Access Compliance Report

Public Rights-of-Way

(Pedestrian Signals)

Intersection ID: N/A	Main Street:	Cross Street: N/A	Location: N/A
ADA ID: E459C1050169	Signal Type: Two Push Buttons-Non APS	Overall Compliance: No	Severity Score: BTN 1:N/A BTN 2: N/A No BTN: N/A
Codes/Mitigation Info/Possible Solution		Field Measurements/Component Compliance

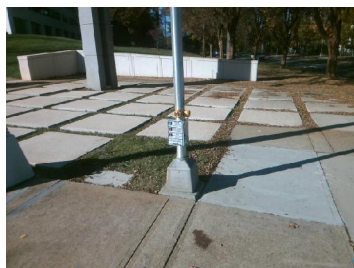
PROW/ADA: TMUTCD 4e.08, R404.2, R406.2, R404.3

Yes	B 1 Clear Xing Direction?	ClearlyMarked	Yes	B 2 Clear Xing Direction?	ClearlyMarked
	B 1 Crossing Direction	To SE		B 2 Crossing Direction	To NE
No	B 1 DistanceTo XWalk (in)	64.0	Yes	B 2 DistanceTo XWalk (in)	0.0
No	B 1 DistanceTo Curb (in)	77.0	No	B 2 DistanceTo Curb (in)	77.0
Yes	B 1 Diameter (in)	2.0	Yes	B 2 Diameter (in)	2.0

Possible Solutions: Replace Signal Push Button With APS Button on New Post. Remove & Relocate Sign.
